**BPC WEST SEWERSHED PACKAGE 5A
SAWS Solicitation No. CO-00449
SAWS Job No. 20-4504**

**ADDENDUM NO. 1
July 28, 2021**

NOTES	INITIALS	DATE
DESIGNED BY	RK	06/21
REVIEWED BY	JB	06/21
SCALE:	AS SHOWN	
SHEET NO.	I-03 41 OF 66

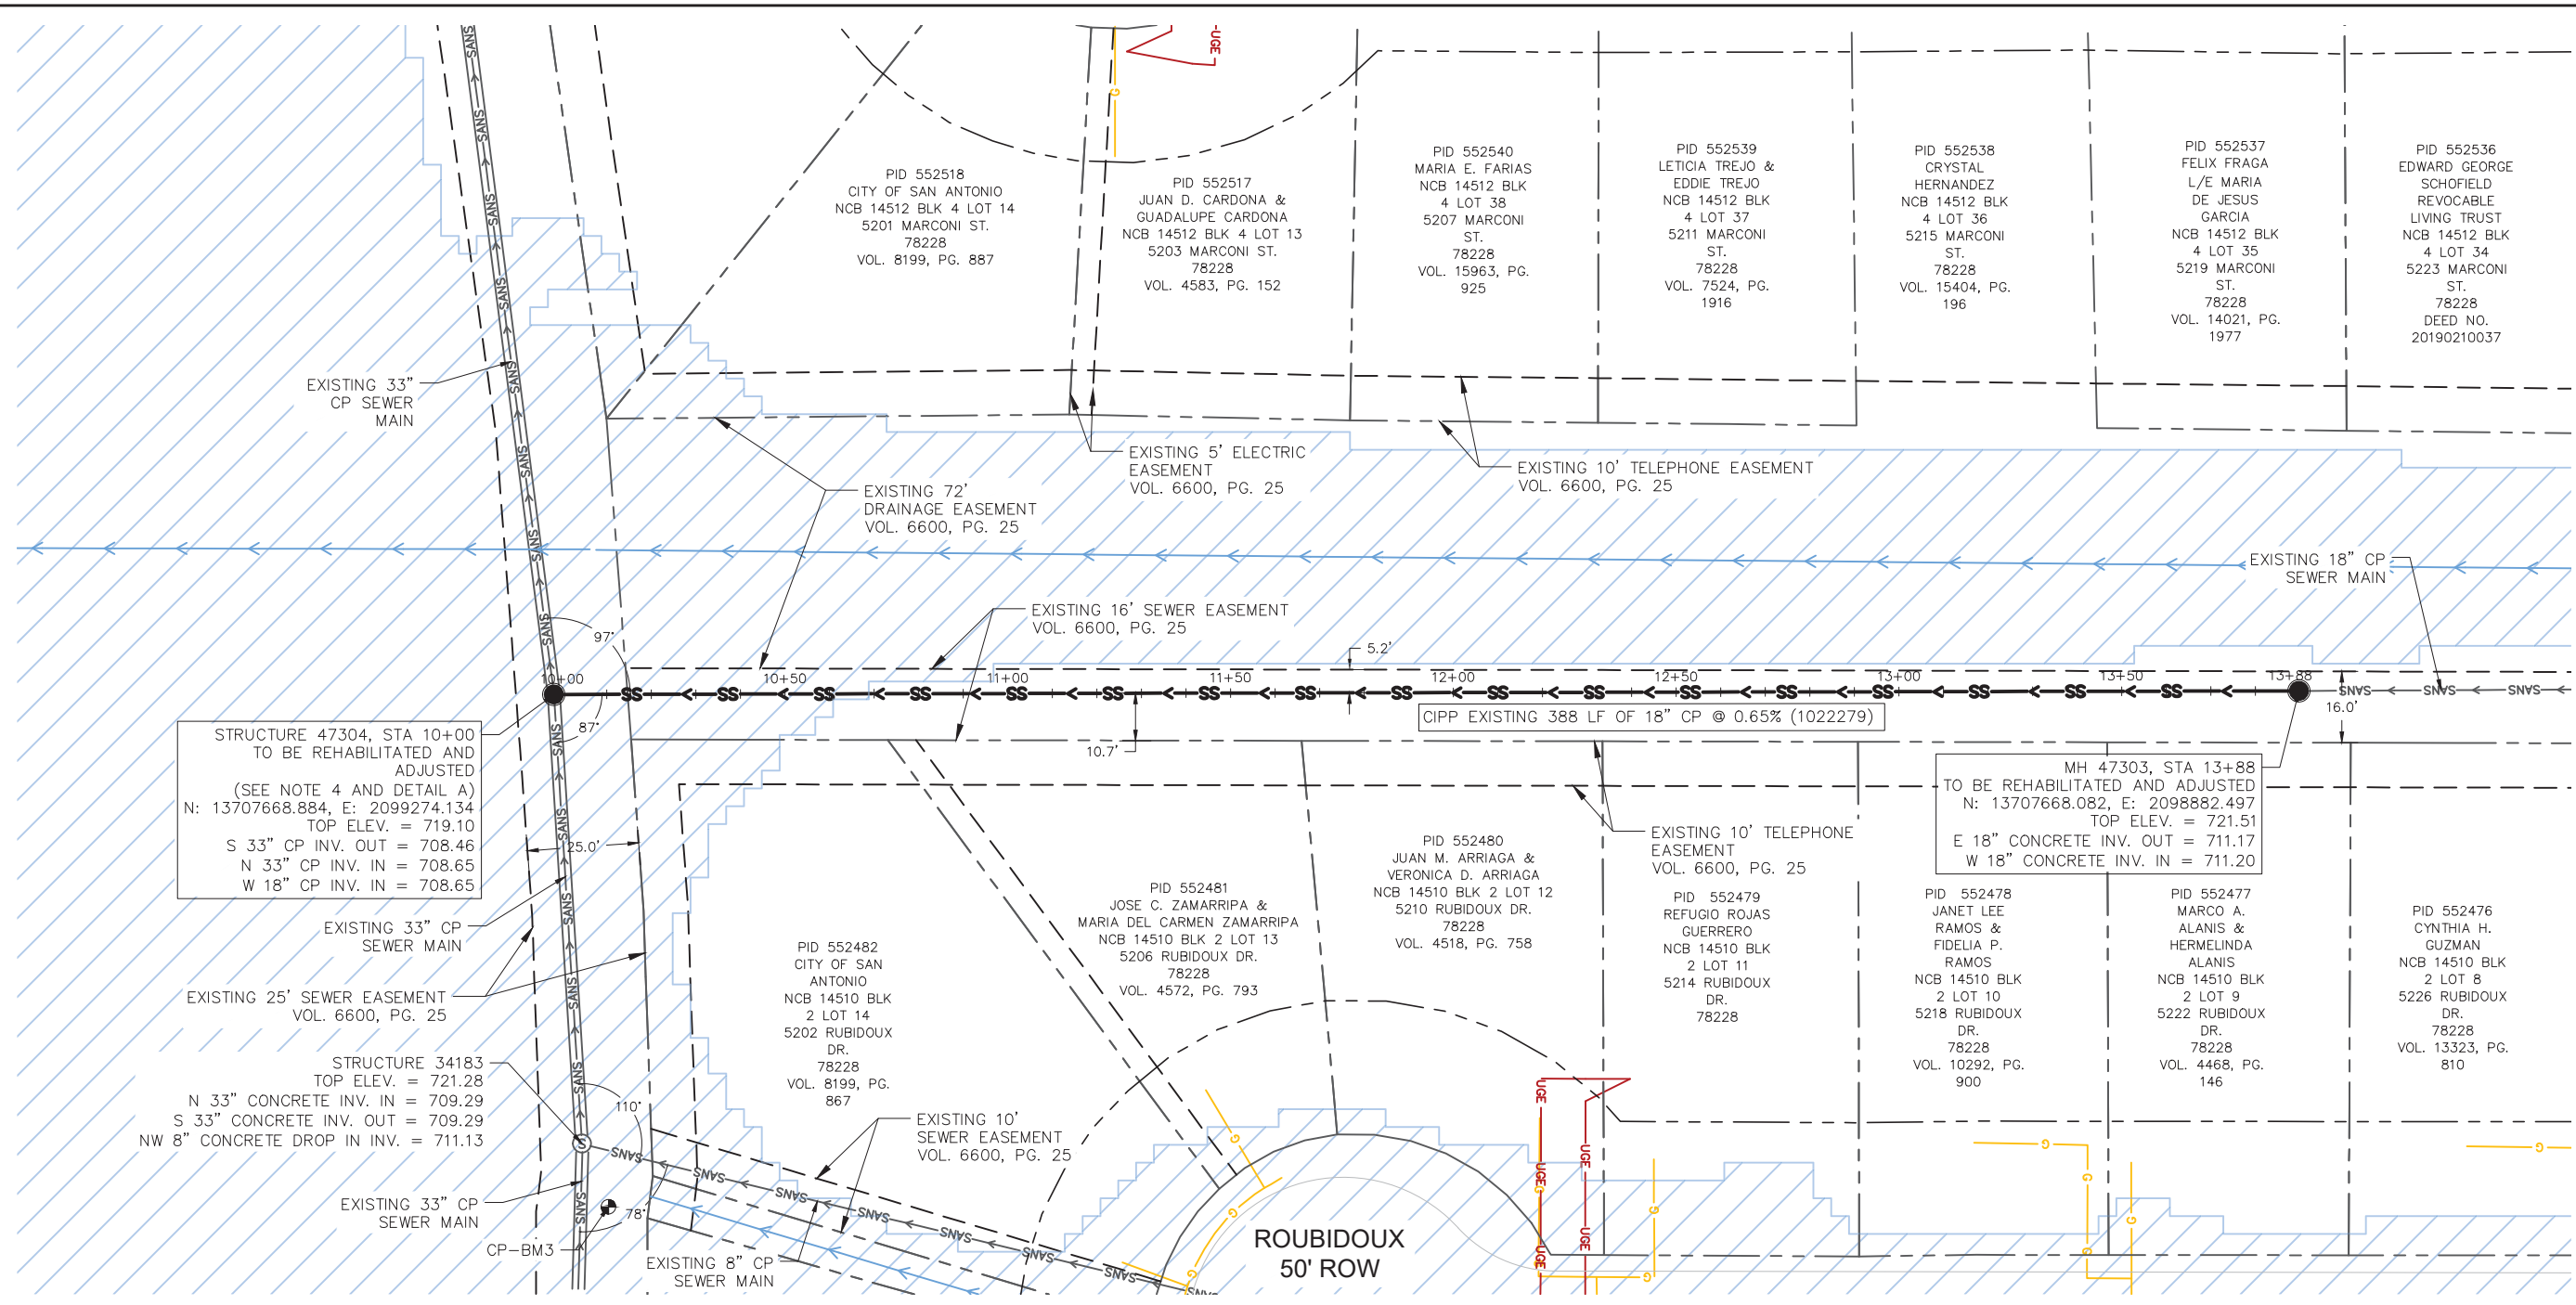
Response: Section 901.4-3.e.7 of Specification 901 Rehabilitation of Sanitary Sewer by Cured-in-Place Pipe (Hot Water) shall remain in place. Refer to Note 5 of the revised plan sheets G-05, G-06, and I-03 attached to this addendum for the 100-year floodplain elevation at sites C-49A, C-49B, and C-55 for contractor's consideration.

1. Remove the following sheets dated 6/23/21 and replace with the attached sheets dated 7/26/2021:
 - a. Sheet G-05 Site C-49A Sewer Rehabilitation Plan – CIPP
 - b. Sheet G-06 Site C-49B Sewer Rehabilitation Plan – CIPP
 - c. Sheet I-03 Site C-55 Sewer Rehabilitation Plan – CIPP

5. THE 100-YEAR FLOOD ELEVATION IS 720.00 FEET.
